LANDMARK COMMISSION**June 1, 2026**

FILE NUMBER: COA-26-000211
LOCATION: 4422 Swiss Ave
STRUCTURE: Noncontributing

A Courtesy Review of the construction of a new multifamily structure (three (3) townhouses) on a vacant (corner) lot with attached garages.

Ext Elevation Front

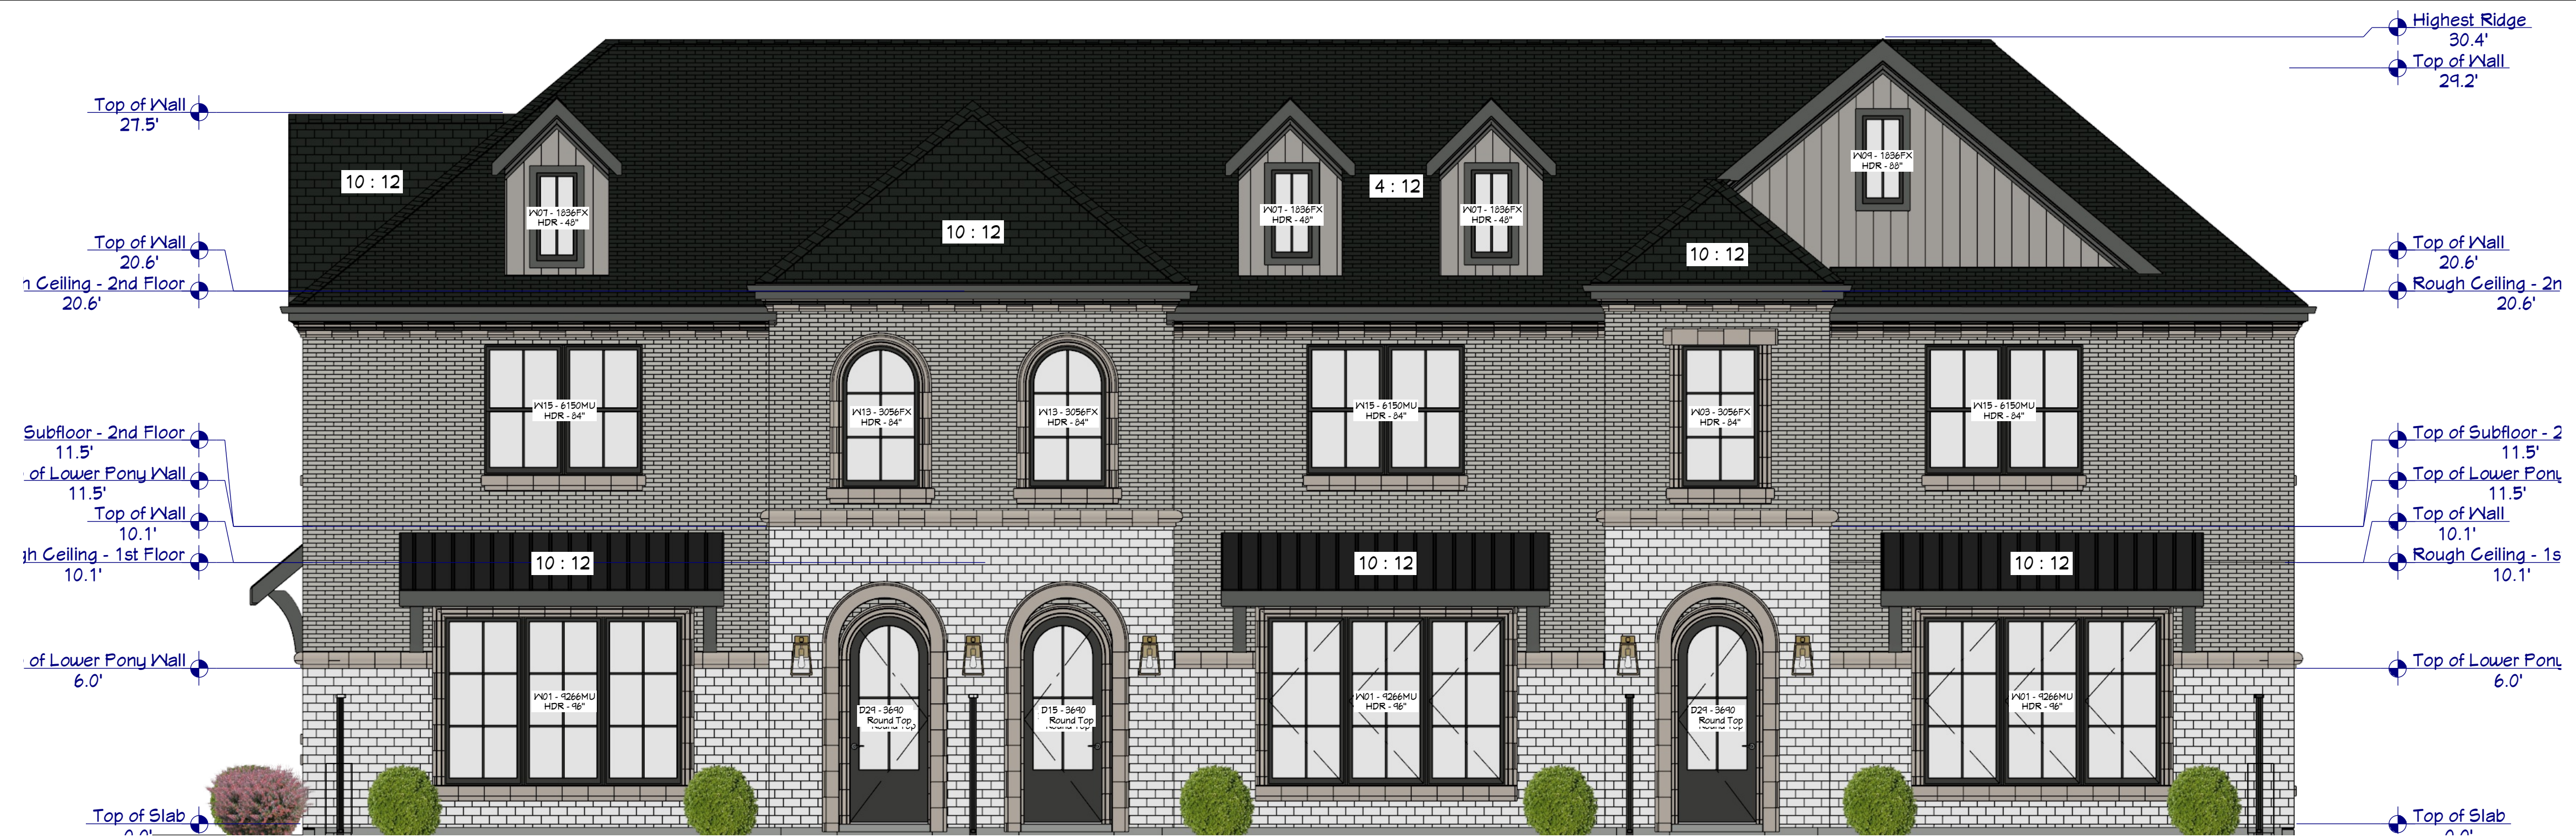
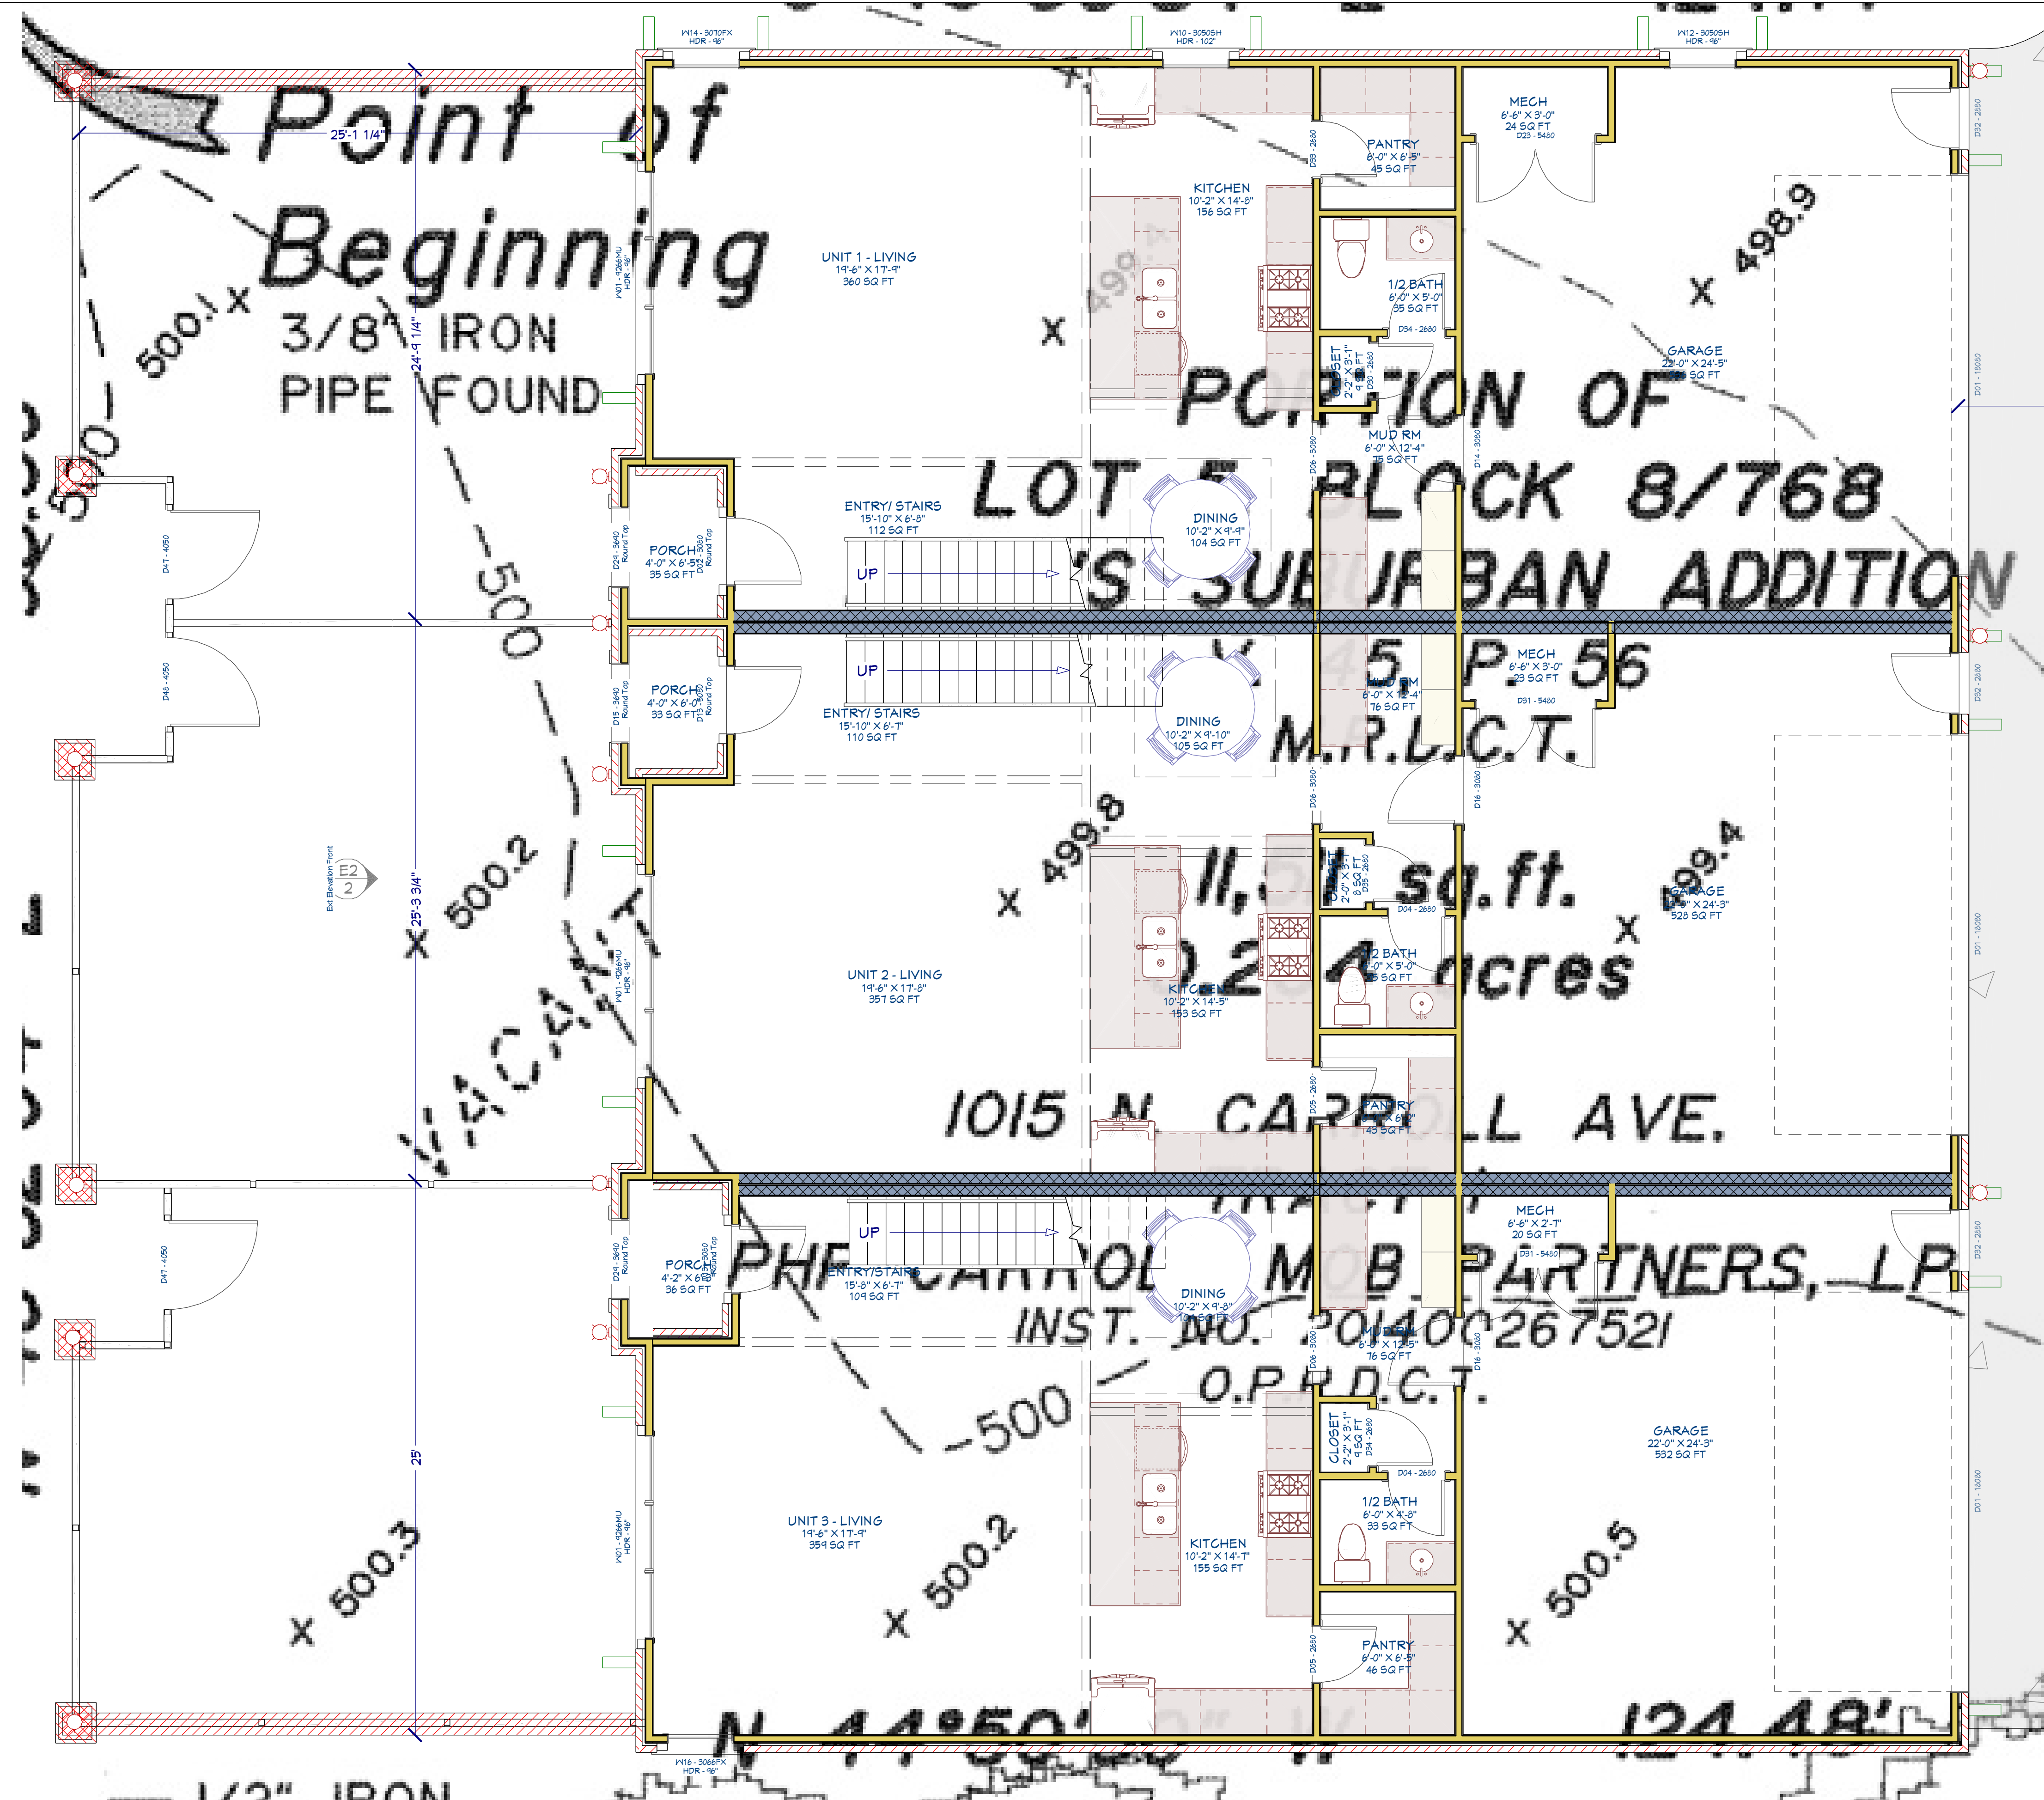
- 1- 18" minimum height from finished grade for porch foundation
- 2- Minimum 24" wide soffit, 8-12" fascia, 12" freize board
- 3- Windows must be wood on wood; no cladding, no internal mullions, and no more than 3 different sizes on the entire structure

- 4- No hardi-board; recommend one brick color rather than two
- 5- Gang windows with a minimum 4 ½-6" trim board in between windows
- 6- Hip roof on garage overhang

- 7- Solid to void ratio needs to be improved. We recommended adding and ganging windows on the front façade, as well as the right and left side facades. Size of windows should be more consistent and of appropriate size for structure

- 8- Porch should be at least 12" deep, which would improve the slope on the front porch roof, bringing the top of it to the bottom of the second floor windows

- 9- Porch columns should brick to one third the height and tapered wooden columns on top 2/3
- 10- Brick columns flanking fence is unusual, but recommend that columns are added at the corners and at the front façade of the structure

SITE PLAN

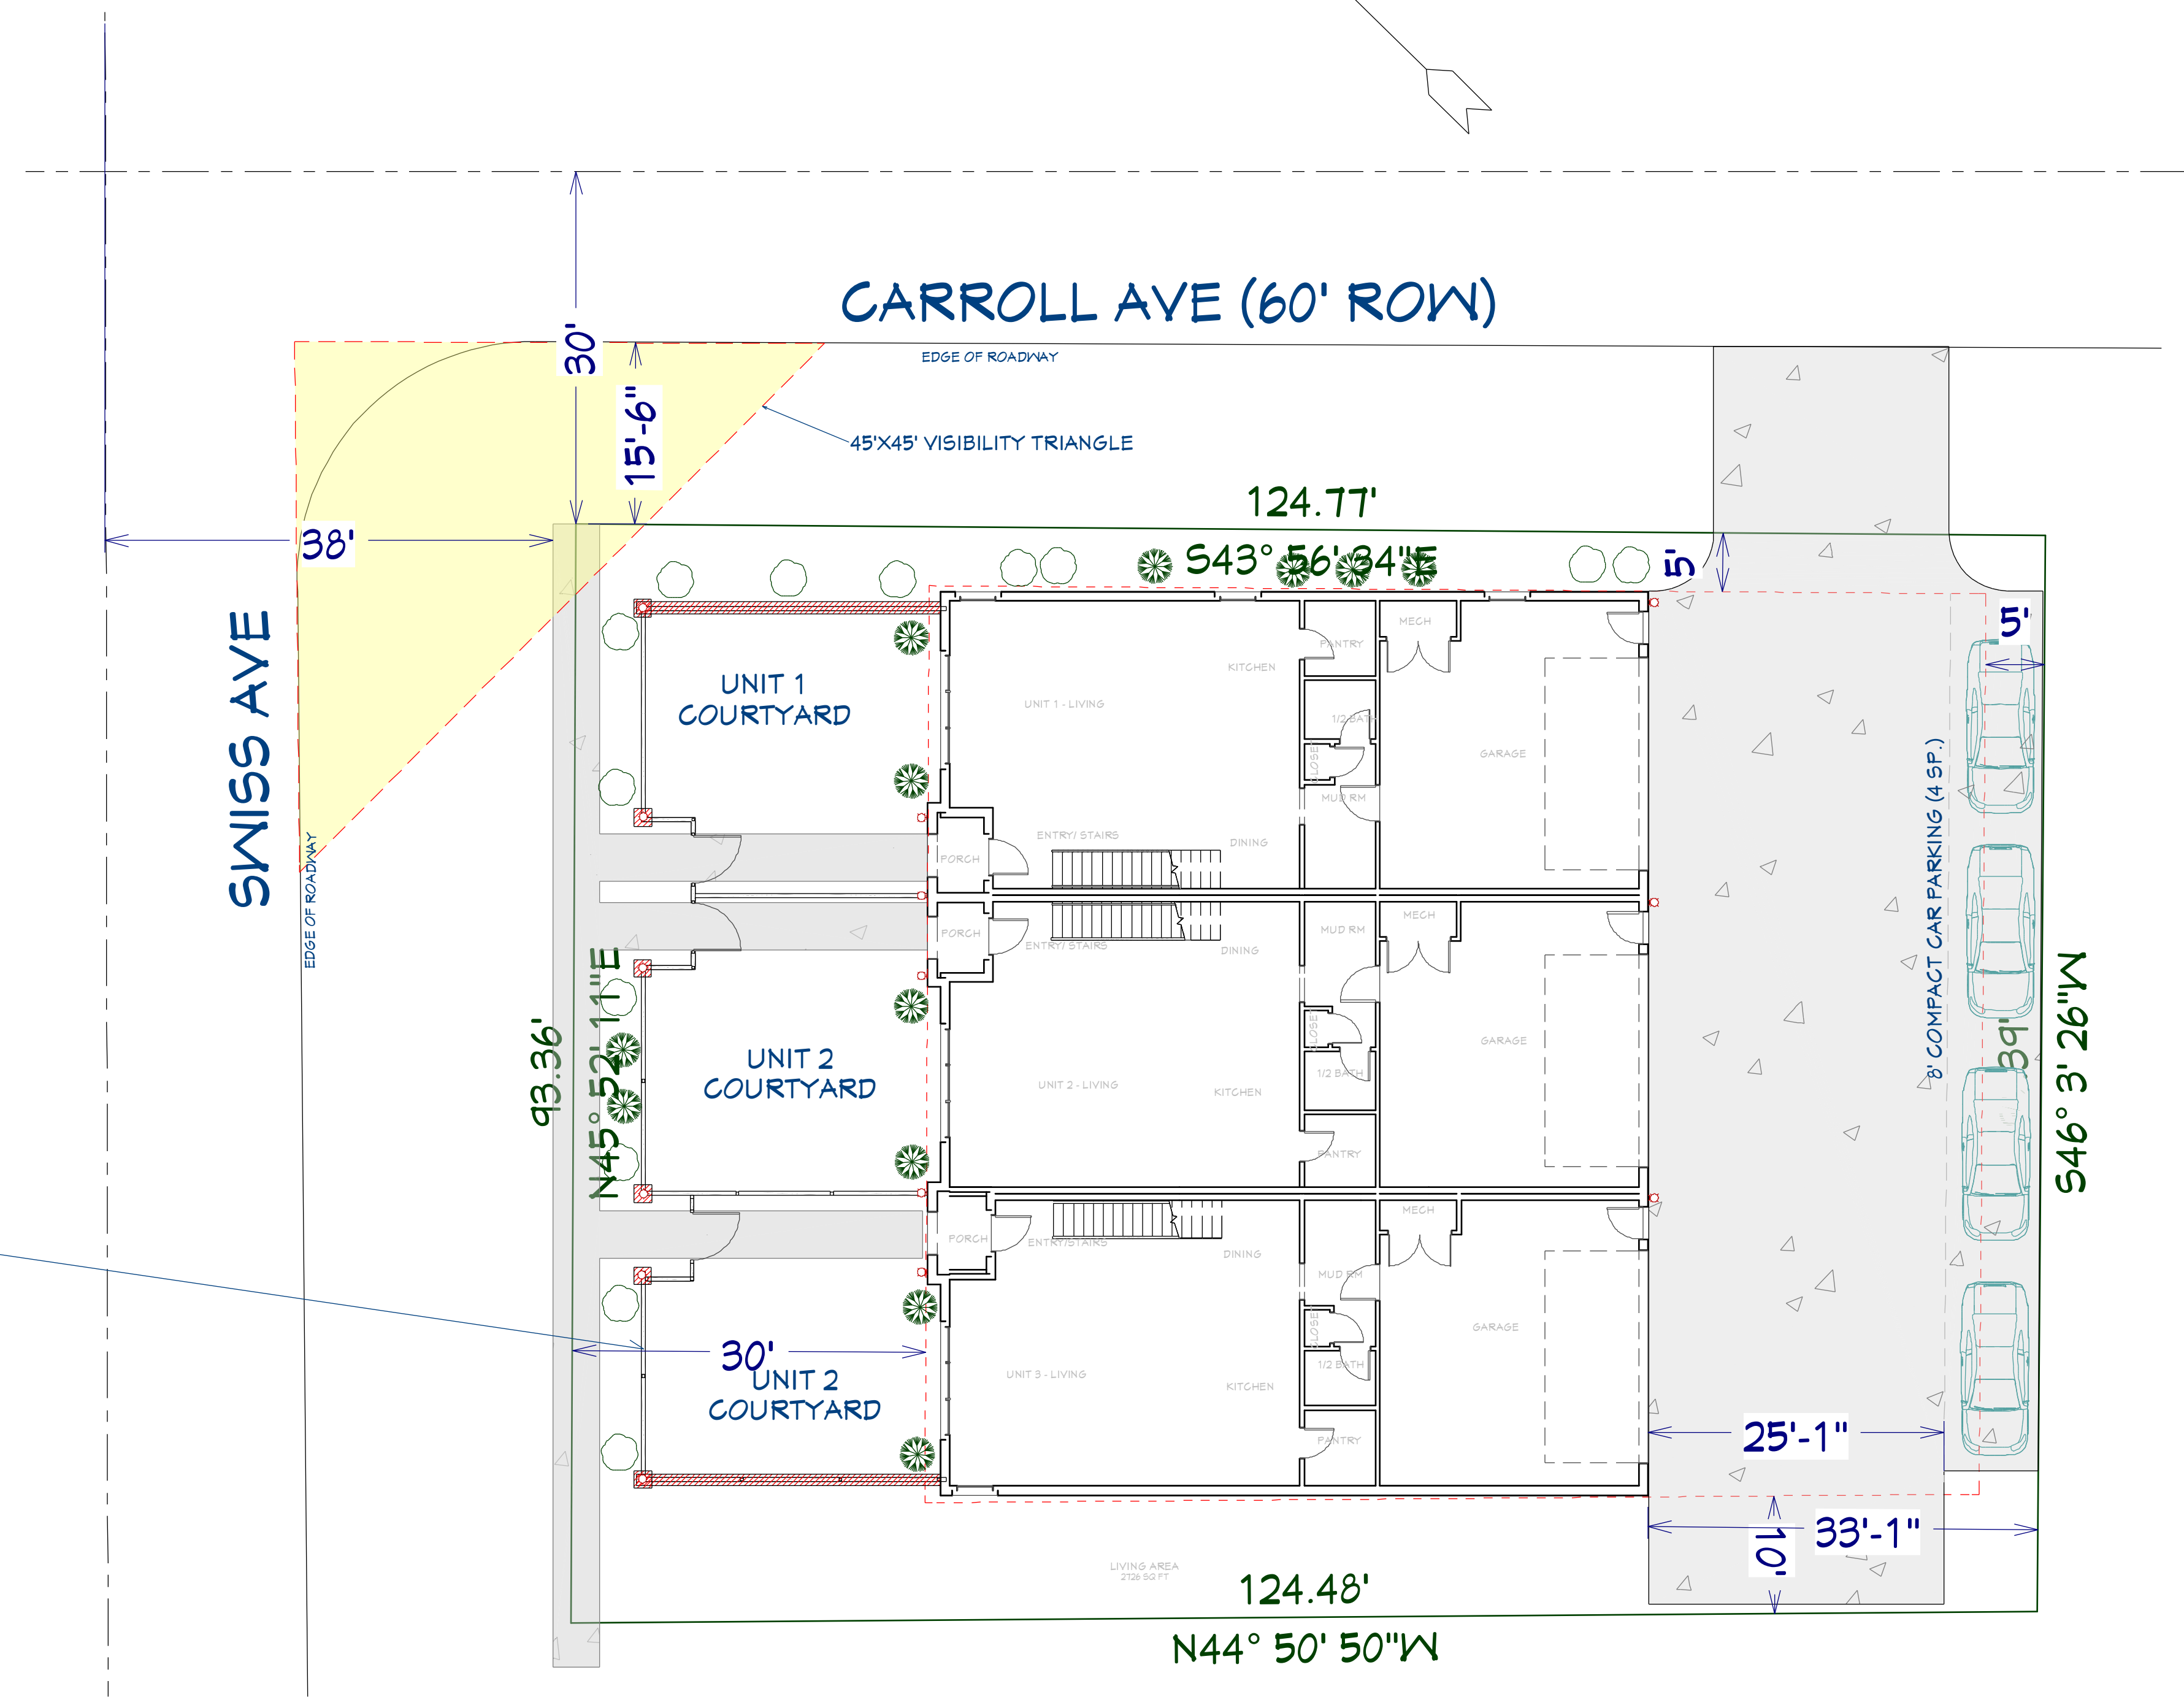
- 10-- Must provide site plan which includes adjacent properties on the block face to evaluate

setback.
